## **IMPORTANT SAFETY RECALL 18V-008 (SN663)**

SN-663

Models Affected: XTPro56 & XTPro 60 Aerials

SUBJECT: Single Stick Control Adjustment

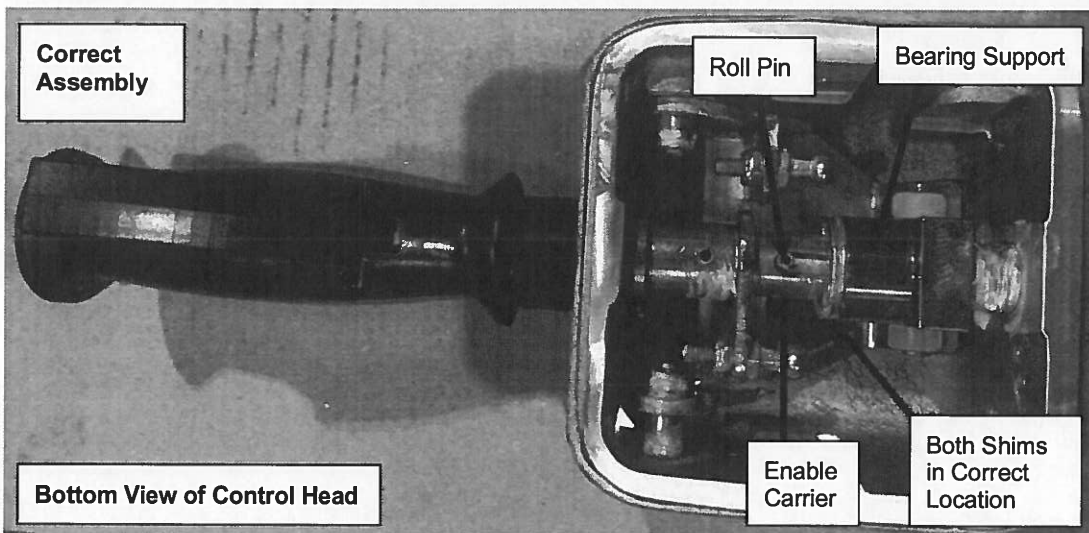
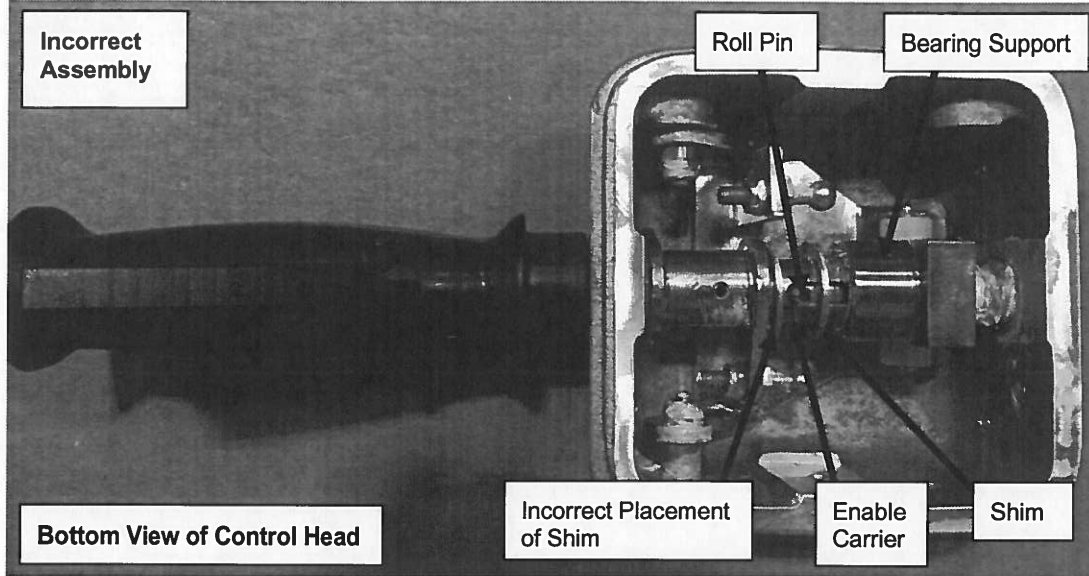
Some XTPro units may have upper control single stick enable trigger adjusted or assembled incorrectly. If the enable trigger is not adjusted correctly, the boom could function without depressing the enable trigger. **Inadvertent boom movement may occur if the single stick is operated without depressing the enable trigger.**

- a. Remove the plastic cap and lower the boot over the single stick mechanism.
  - b. Inspect the position of the two shims on the enable carrier.
  - c. If only one shim is between the roll pin and bearing support, the single stick is assembled incorrectly. Contact your local TEREX dealer to arrange repair. The control head must be assembled properly to provide allowance for wear to attain rated boom speeds.

- d. If both shims are between the roll pin and bearing support, the single stick is assembled properly. No further action is required for this bulletin. Continue to perform regular inspections and maintenance as stated in the manuals.
